Ref: 191251_Let5_Rev2

Re: SSD-10407 - Yennora Liquid Waste Facility – Vehicle Maneuverability

PROJECT TITLE			
PROPOSED INDUSTRIAL ALTERATION AND ADDITION			
14 - 16 Kiara Crescent, Yennora			
DRAWING TITLE			
SITE PLAN			
PROJECT NUMBER	DRAWING NUMBER	DATE	REVISION
20097	02	06/26/20	A
SCALE @ A1		DRAWN BY	CHECKED BY
1 : 100		GA	CB

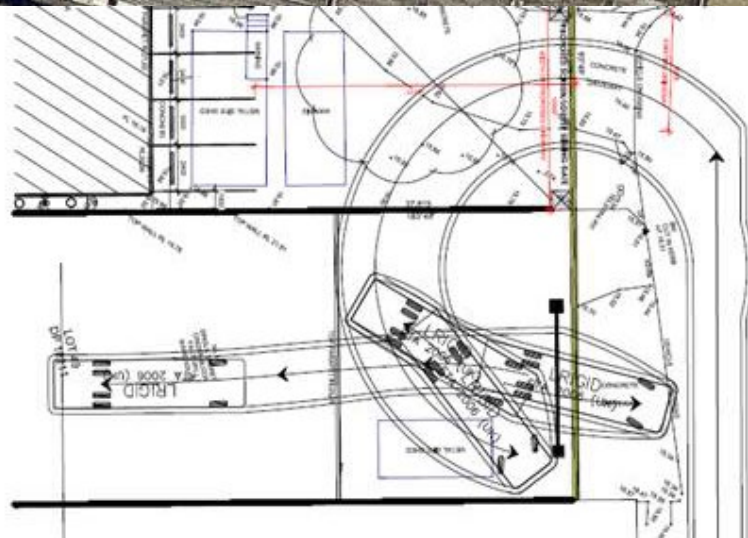
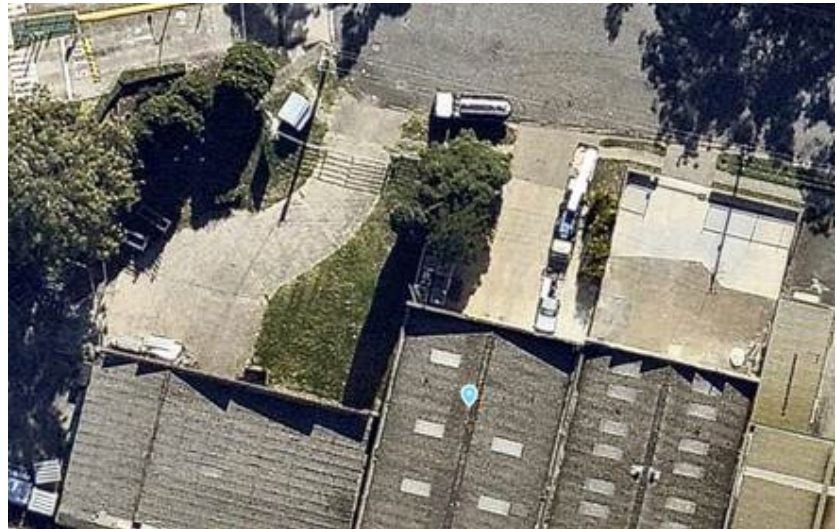
- a) The 10.0m truck used in the swept path analysis is a not a standard truck that is defined in Australian standard AS2890.1.
- b) The swept path analysis shows that the turning path encroaches into Council's land (footpath and nature strip).

- c) Reverse manoeuvring in Council's land is not acceptable. It will compromise the safety. Vehicles should enter and leave the site in a forward direction.
- d) Proposed 4 point turn truck manoeuvring movement is not acceptable. Manoeuvring shall be limited to three point turn.
